1
2 **DOCUMENT 00 91 13**
3

8 ADDENDUM NO.1 Date: 08.02.21
9

10 RE: SAUK COUNTY COURTHOUSE AND HUMAN SERVICES BUILDING RENOVATIONS
11 515 OAK STREET, BARABOO, WI 53913 and
12 425 6TH STREET, REEDSBURG, WI 53959
13

2 FIRST FLOOR DEMOLITION PLAN - LIGHTING
E101.1 SCALE: 1/4" = 1'-0"

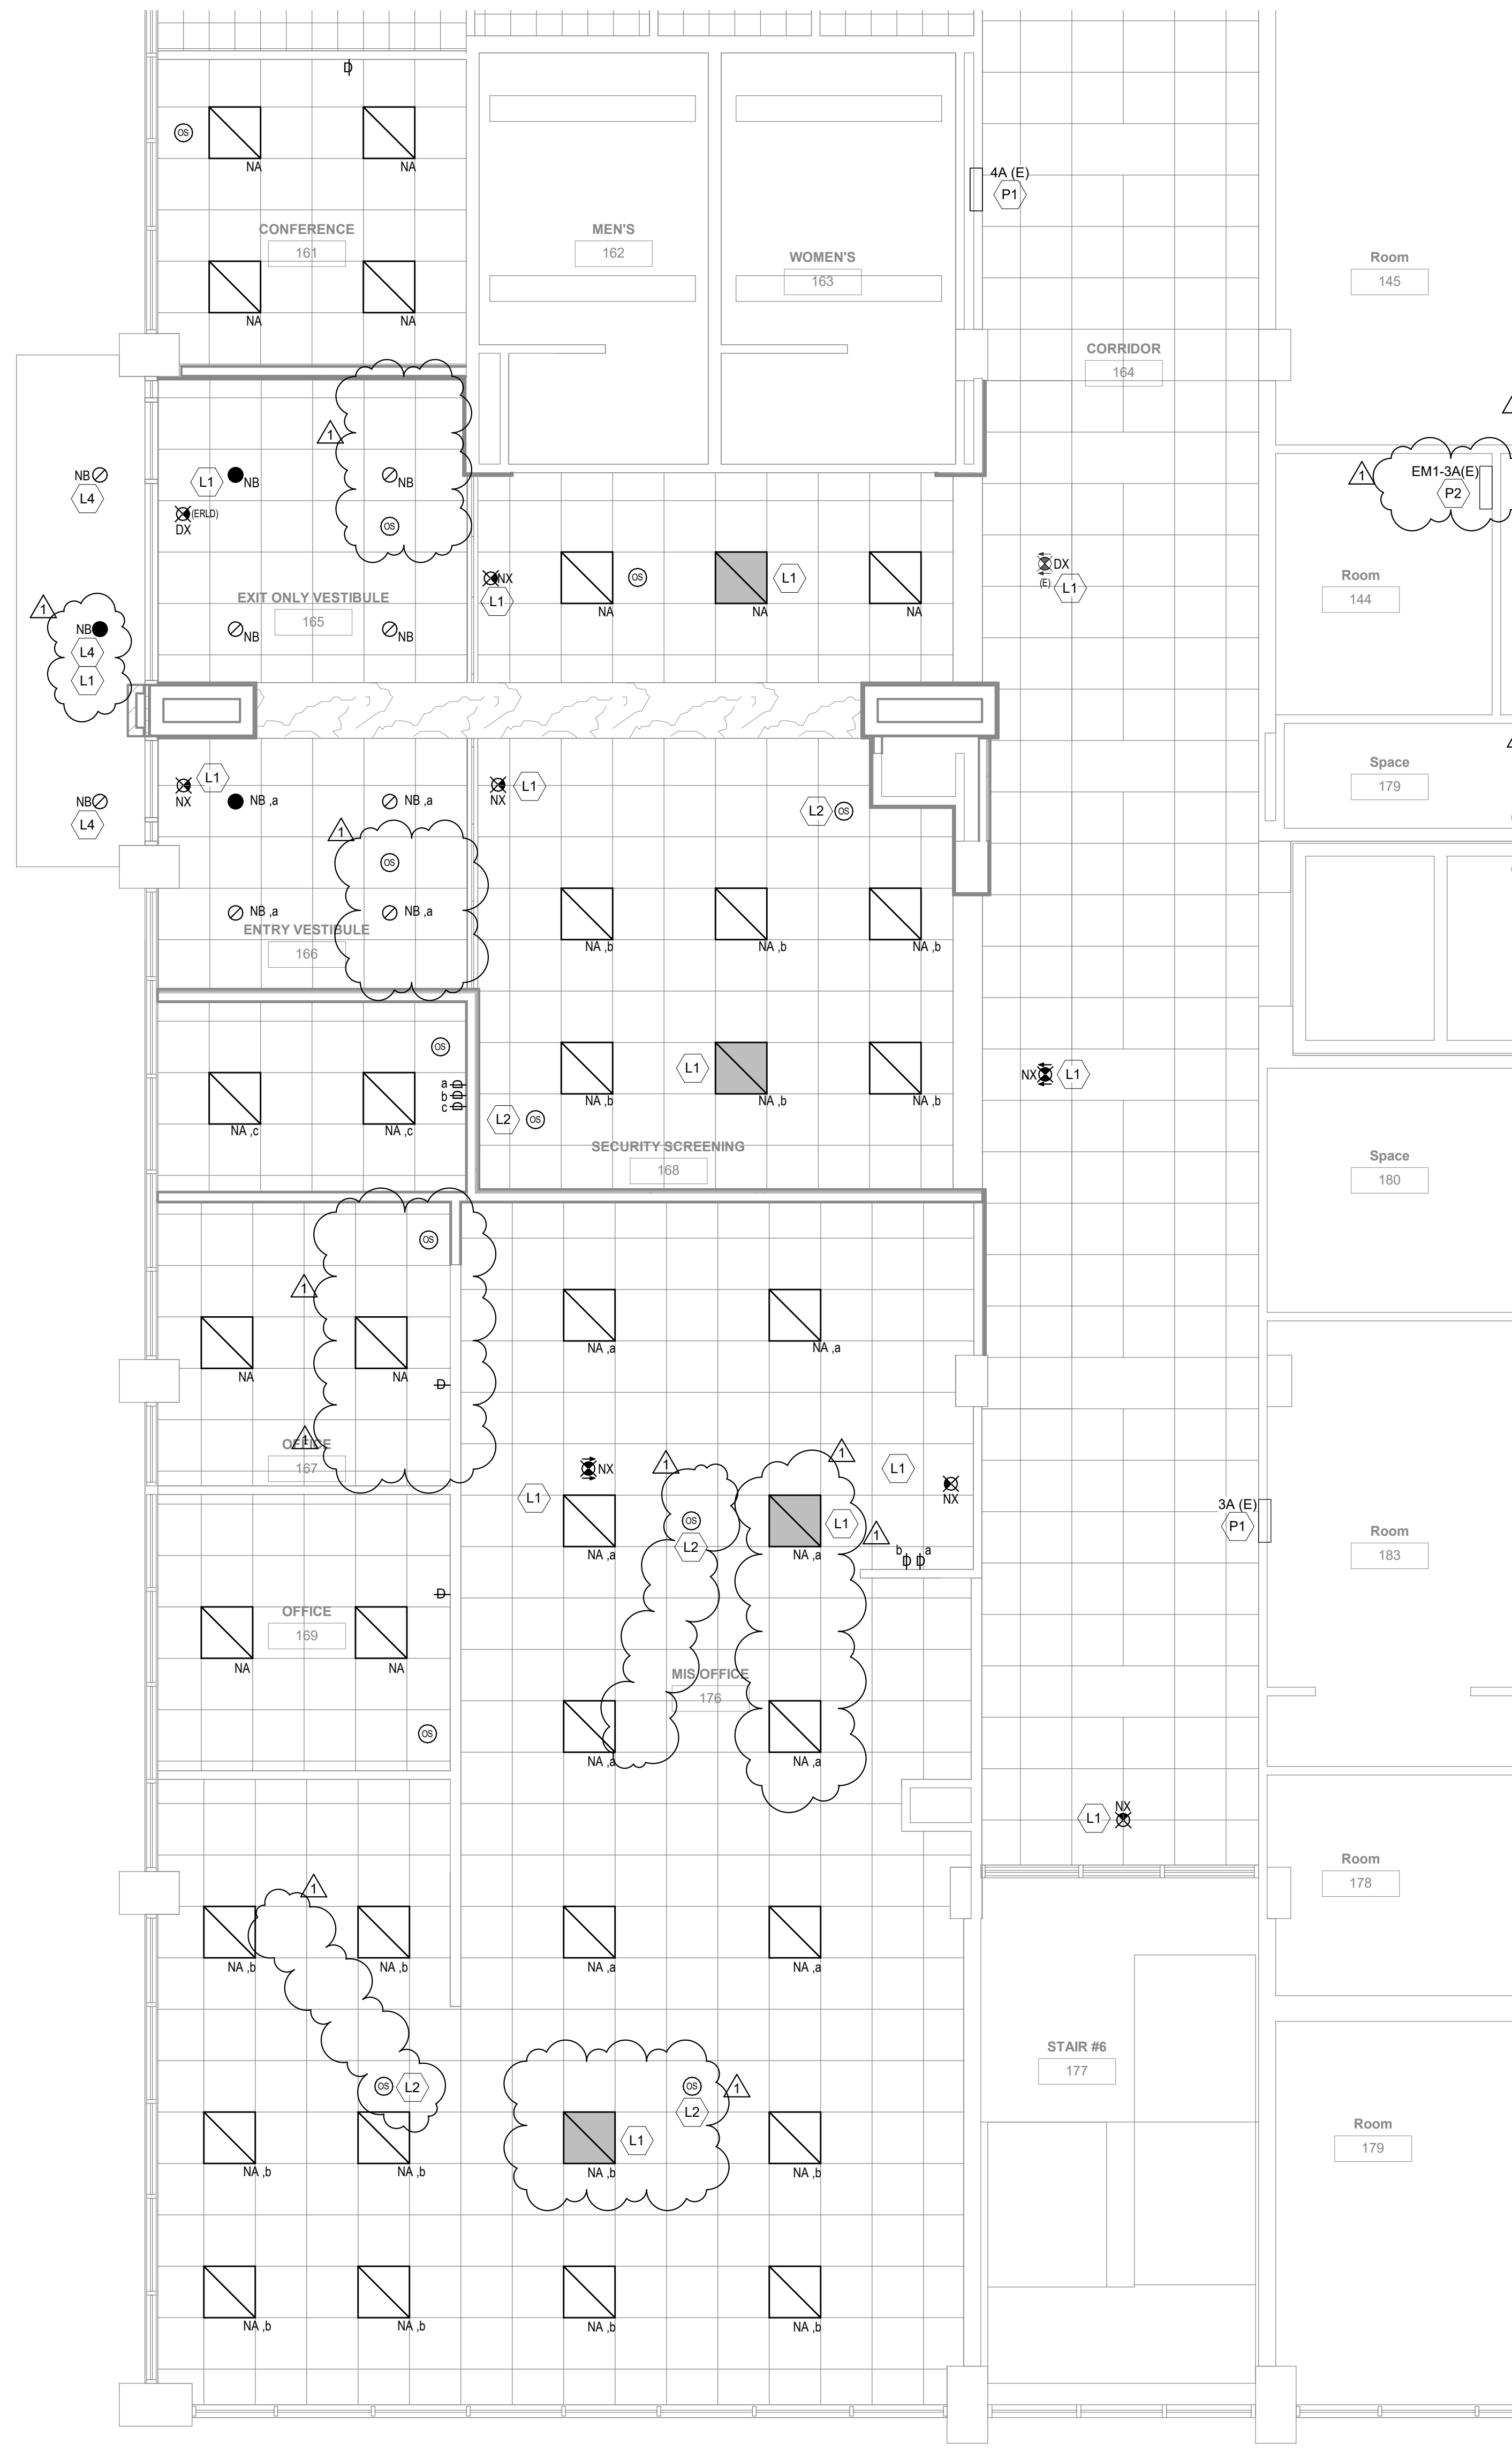
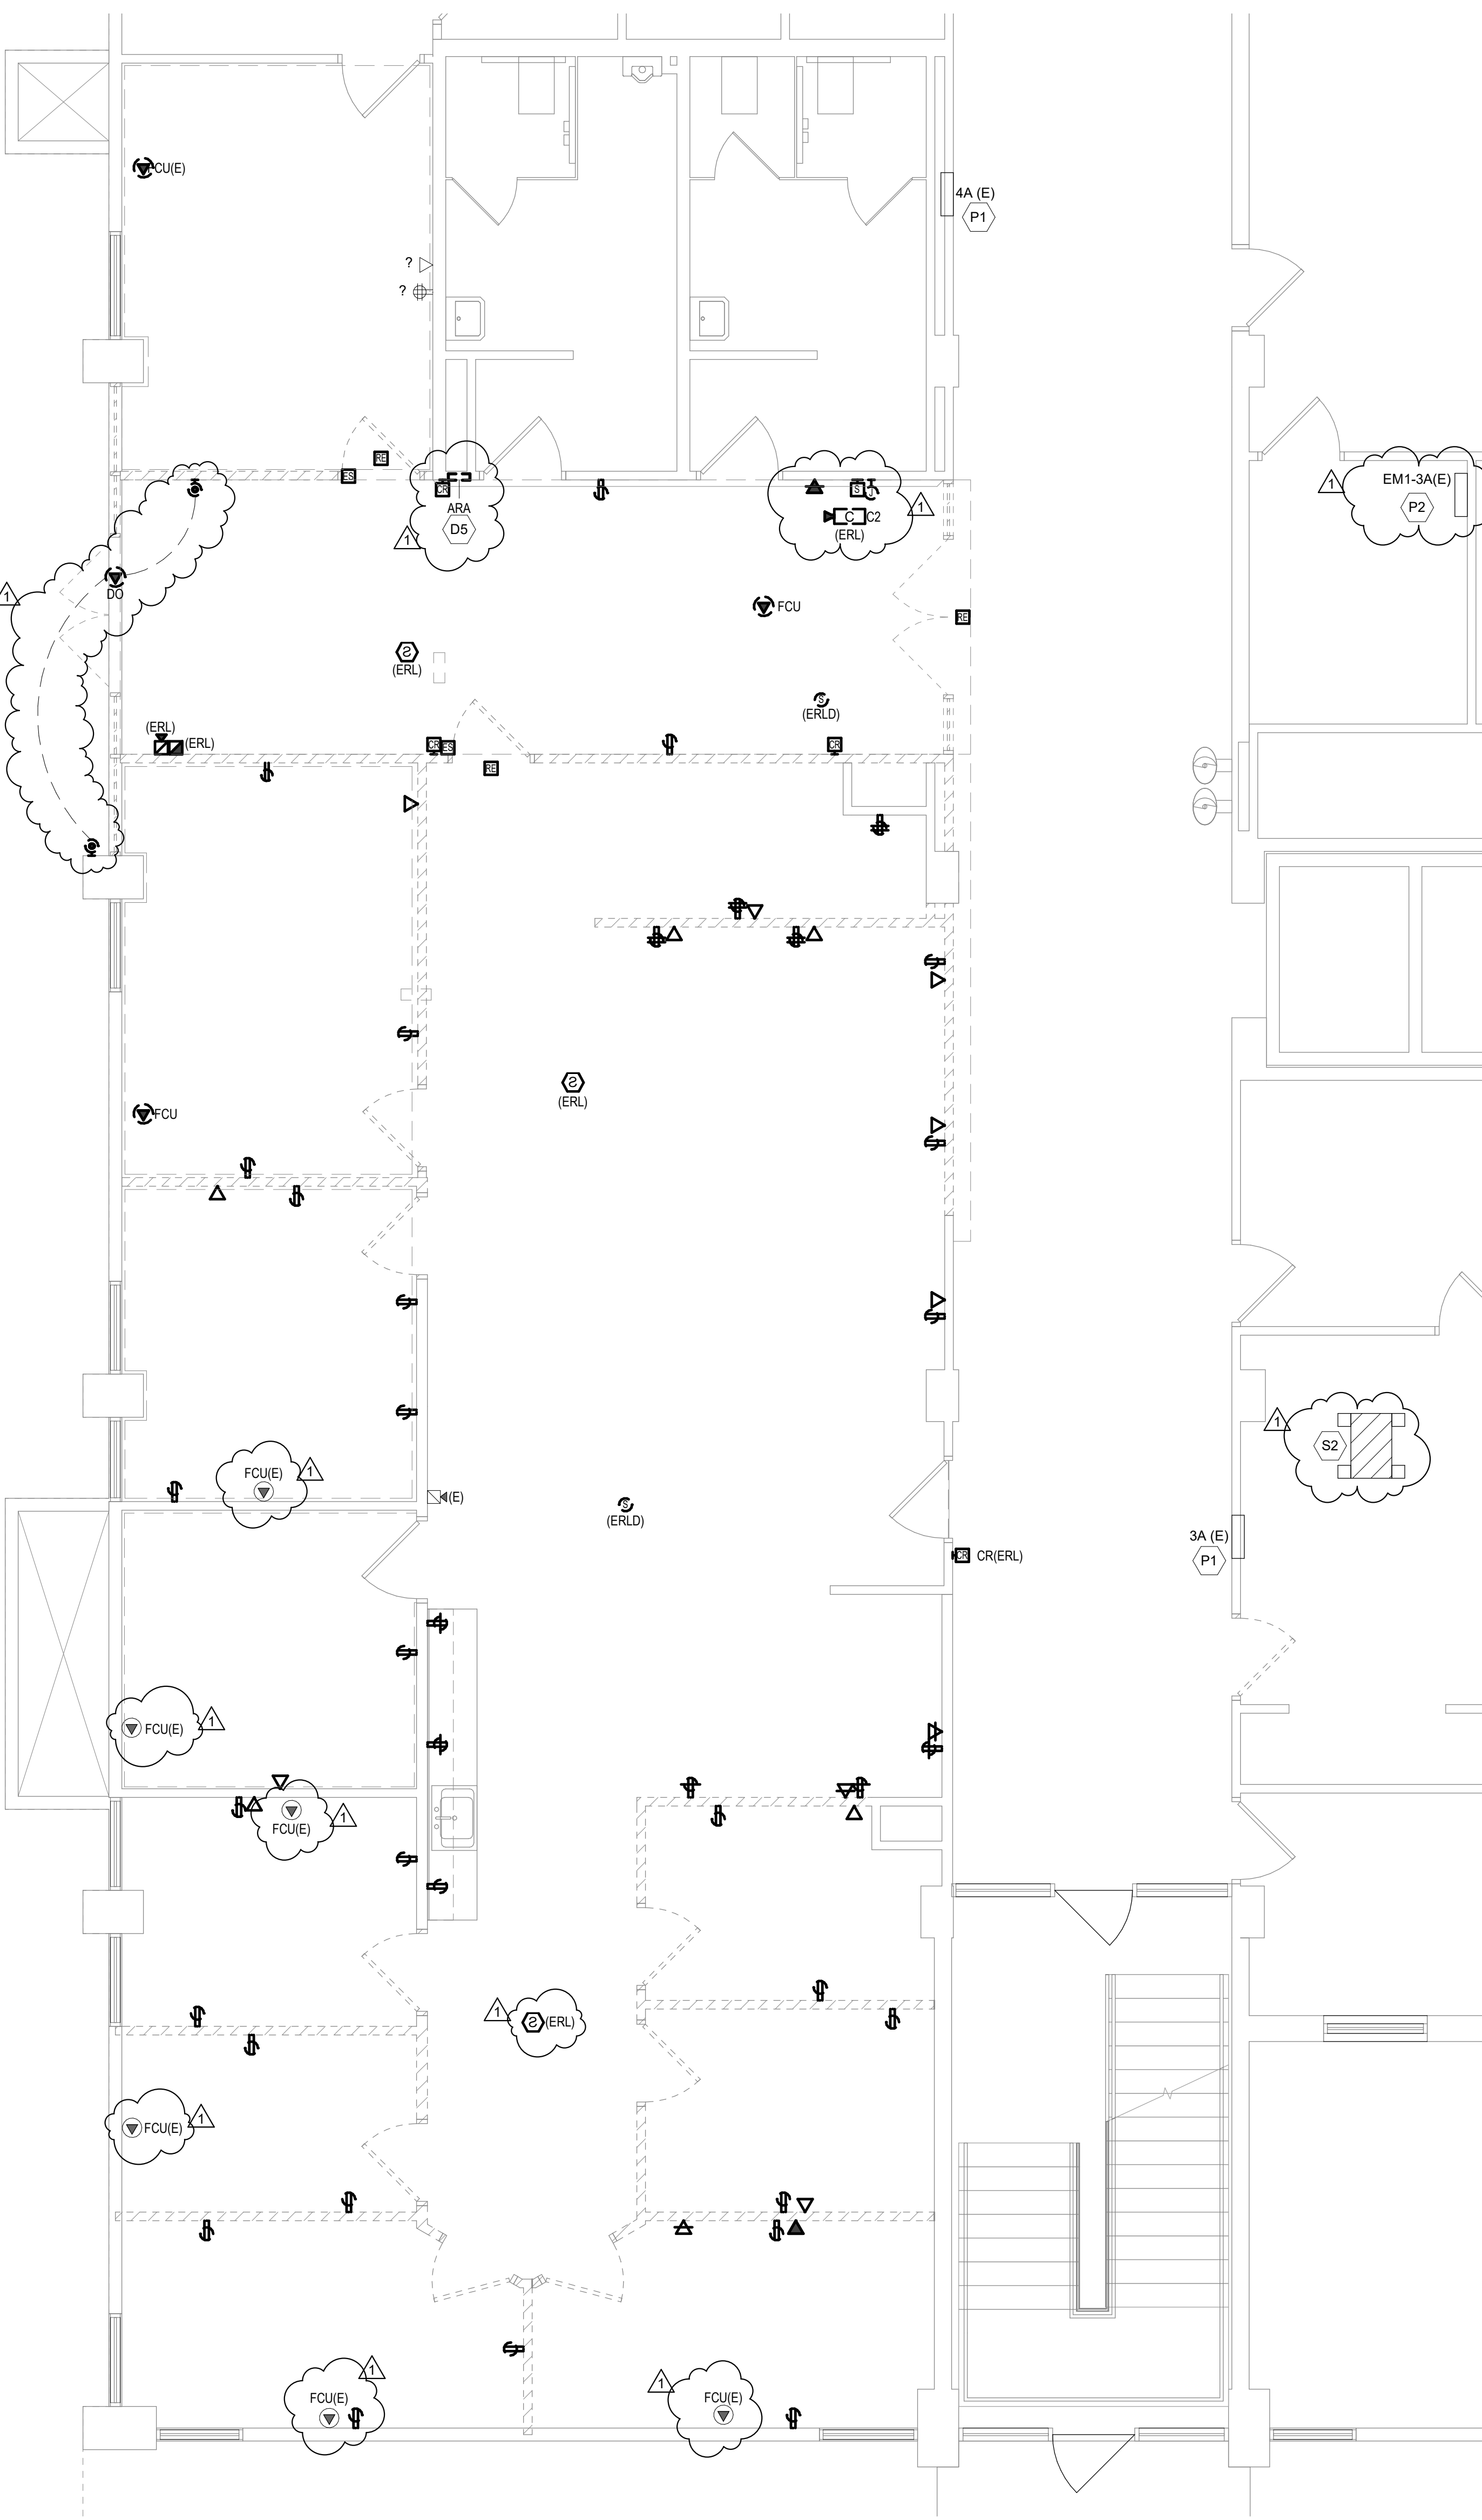
32 183.
33
34 4. SHEET A700.1, DOOR SCHEDULE
35 a. Revise Opening 166 Hardware Set to 8.0.
36
37 5. SHEET A901.1, FIRST FLOOR FINISH PLAN
38 a. Replace all references to CT-1 with CT-2.
39 b. Delete reference to CT-X in Exit Only Vestibule.
40
41 6. SHEET S101, FOUNDATION PLAN
42 a. Replace sheet S101 in its entirety with attached S101.
43
44 7. SHEET E000.1, SYMBOLS, ABBREVIATIONS & DETAILS – ELECTRICAL
45 a. Replace sheet E000.1 in its entirety with attached E000.1.
46 b. Revised Schedules and Symbols List.
47 c. Removed detail #2.
48
49 8. SHEET E001.1, SITE PLAN – ELECTRICAL
50 a. Replace sheet E001.1 in its entirety with attached E001.1.
51 b. Revised General and Keyed Notes.
52 c. Added Flagpole light fixtures and associated Keyed note.
53 d. Added keyed note to NC light fixtures.
54
55 9. SHEET E101.1, FIRST FLOOR PLANS – LIGHTING
56 a. Replace sheet E101.1 in its entirety with attached E101.1.
57 b. Revised General and Keyed Notes.

58 c. Revised lighting layout.
59
60
